BROADVIEW ACCESS MANAGEMENT REVIEW

US 211/US17/29 BUS (BROADVIEW AVENUE), WARRENTON, VA

Date: August 27, 2018 Project #: 21905
To: Brandie Schaeffer, Town of Warrenton
From: Chris Tiesler, PE; Bradley Reynolds, PE; and Andy Butsick, PE

Exhibit 1. Cross-Section Concept with Landscaped Medians with Openings and Buffered Bike Lanes

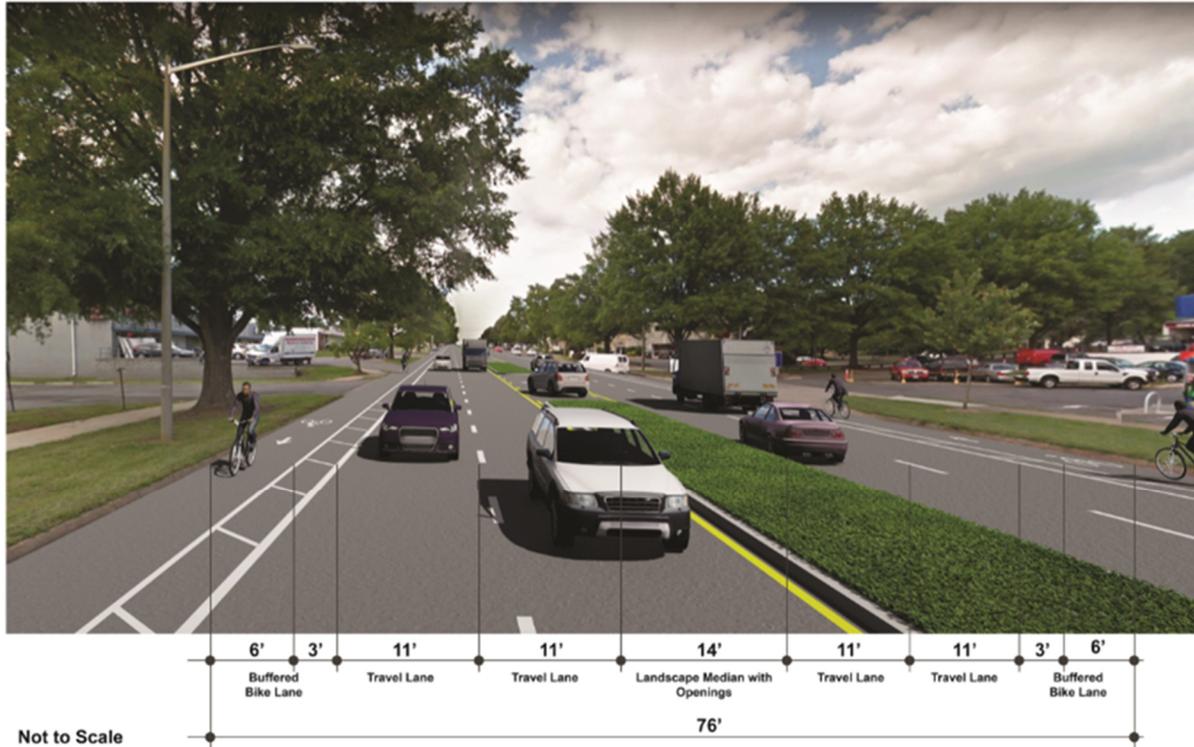
In consultation with the Town of Warrenton's decision makers and staff, Kittelson has prepared an access management concept plan reflective of the Town of Warrenton's preferred concept that modifies VDOT's plan to provide a four-lane facility with landscape medians and center two-way left-turn lanes (CTWLTL) and buffered bike lanes along the Broadview Avenue corridor. This conceptual plan attempts to incorporate developed design studies and established project goals, as detailed in the ADA/Access Management/Traffic Assessment Report, VDOT, April 2015, along with the Town of Warrenton's vision for the corridor and complete street initiatives by implementing the following:

- Installation of medians and center two-way left-turn lanes – A total of approximately 8 median breaks/CTWLTL segments within the Broadview Avenue study corridor, a similar number of median breaks proposed in the *Broadview Access Management Study, VDOT, February 2013*.

- Installation of left-turn lanes.
- Turning movement restrictions.
- Driveway access restrictions.
- Installation of two segments of CTWLTL. The southern segment is approximately 650' in length from Station 128+50 to Station 134+50. The northern segment is approximately 450' in length from Station 151+00 to Station 155+50.

- Improved lighting.
- Improved pedestrian and bicycle facilities – Improved sidewalk, ADA facilities, buffered bike lanes, and on-road bike lane to sidewalk transitions.

Exhibit 3. Warrant 2 (Four-Hour Vehicular Volume) – Broadview Avenue/Gold Cup Drive

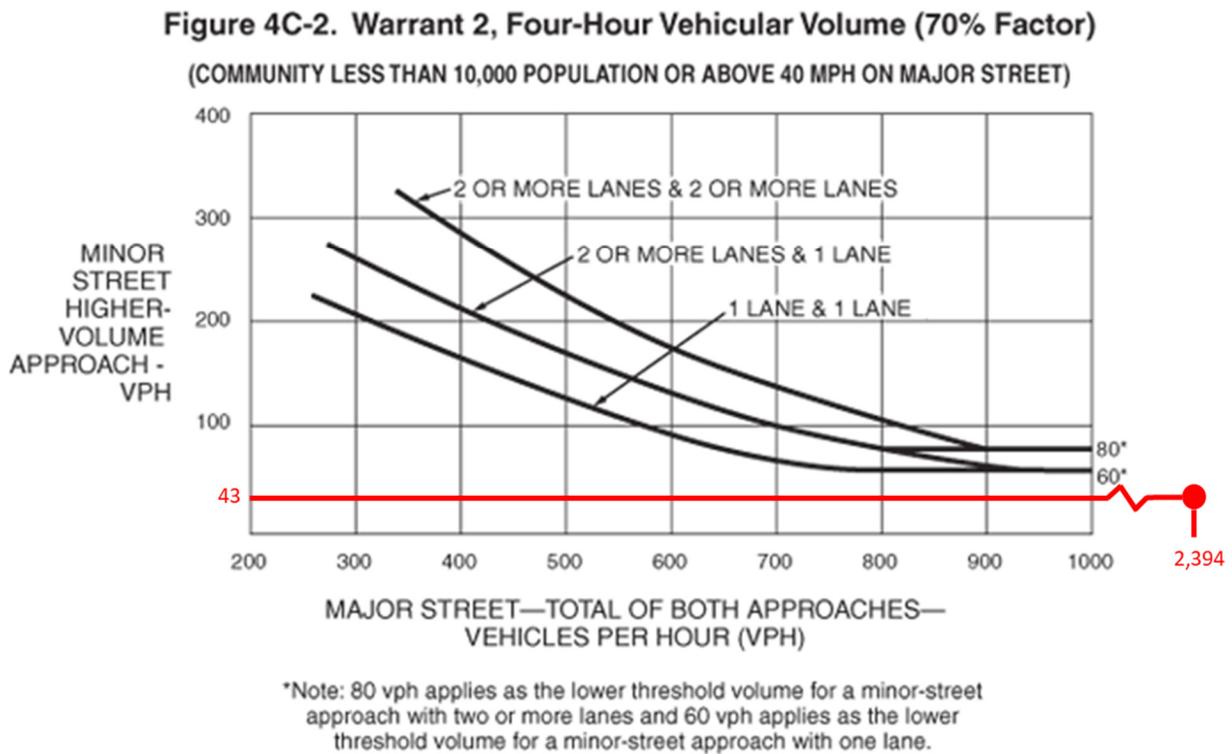
In accordance with the MUTCD, *Warrant 2, Four-Hour Vehicular Volume* is to be applied where the volume of intersecting traffic is the principal reason to consider installing a traffic signal. The warrant requires that any four (4) hours (i.e., the 4th highest hourly volume) on an average day plotted on the applicable curve to determine the need for a traffic signal. **Exhibit 3** shows the 4th highest hour volumes plotted on Figure 4C-1 of the MUTCD.

As shown in **Exhibit 3**, the 4th highest hour volumes do not exceed the minimum thresholds and do not warrant a traffic signal.

Exhibit 4. Warrant 3 (Peak Hour Volume Volume) – Broadview Avenue/Gold Cup Drive

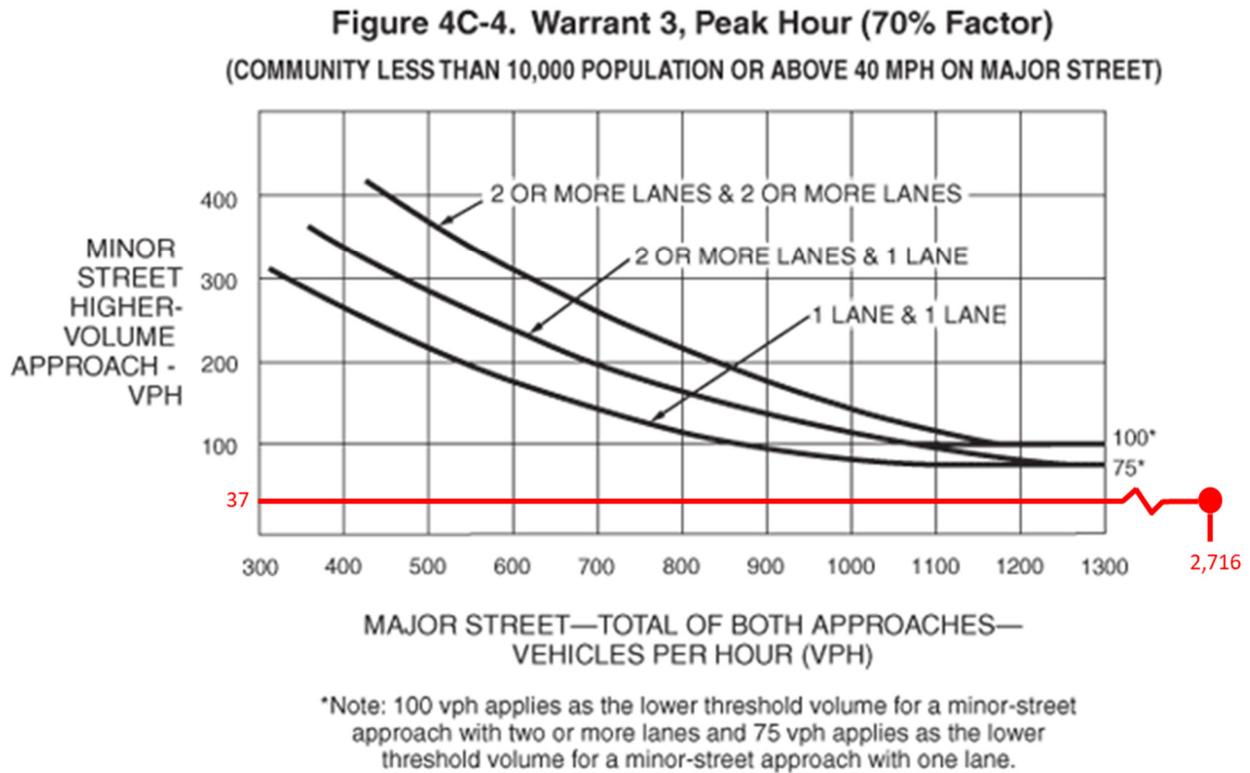
Error! Reference source not found.4 shows the peak hour volumes as plotted on Figure 4C-3 of the MUTCD.

As shown in **Exhibit 4**, peak hour volumes do not exceed the minimum thresholds for an intersection with a one-lane minor street and do not warrant a traffic signal.
